# Permit of Authorization to Construct an On-Site Sewage Facility Permit Valid For One Year From Date Issued

Permit Number: 118644

RE- Septic Design
10321 REBECCA CREEK ROAD
H. RAISNER SURVEY NO. 53, A-489, BEING 14.615 AC
SPRING BRANCH, TX 78070
ENZOR RESIDENCE

RE: 10321 Rebecca Creek Rd. 13.786 Acre Tract out of the H. Raisner Survey No. 53, Abstract No. 489

#118644

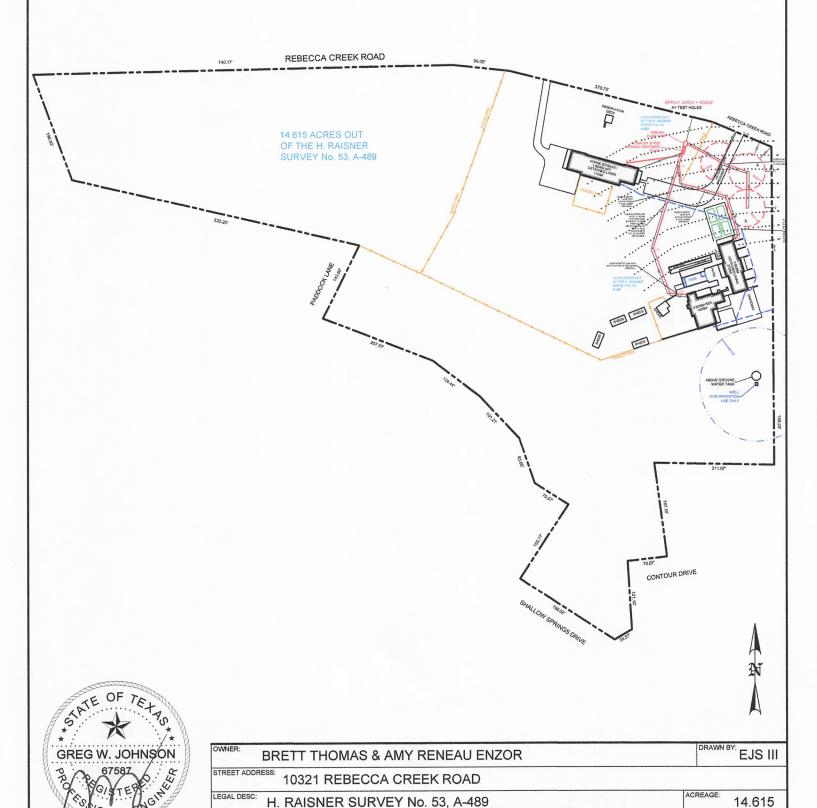
- Our office will be conducting a site visit on 06-09-2025.
  - Based on the GIS imagery the layout of the structures looks different from the submitted site plan.
- The deed provided is for 13.786 acres, the site plan is for 14.615 acres.
  - Provide a deed for the additional acreage or show only the 13.786 acres.
- What is the reason for the variance request?
  - There appears to be adequate space to meet the 20ft separation distance.
- What are you purposing for protection for the sewer line beneath the sidewalk that leads to a shed.
- What protection are you purposing for the spray head within 5ft of the driveway?
- 6. Revise accordingly and resubmit.

- 1. Many of the structures have been demolished and replaced.
- 2. Attached is the additional deed information for the 0.829 acres for a total of 14.615 acres.
- 3. Variance request is due to the other area have equine.
- 4. Showing sleeving with Sch-40 PVC under sidewalk
- 5. Setback not required. Placing Sch-40 PVC around spray head can reduce damage potential.

NOTE: **EXISTING SEPTIC TANK TO** BE PUMPED, CRUSHED AND BACK FILLED.

**EXISTING SEPTIC SYSTEM** TO BE ABANDONED
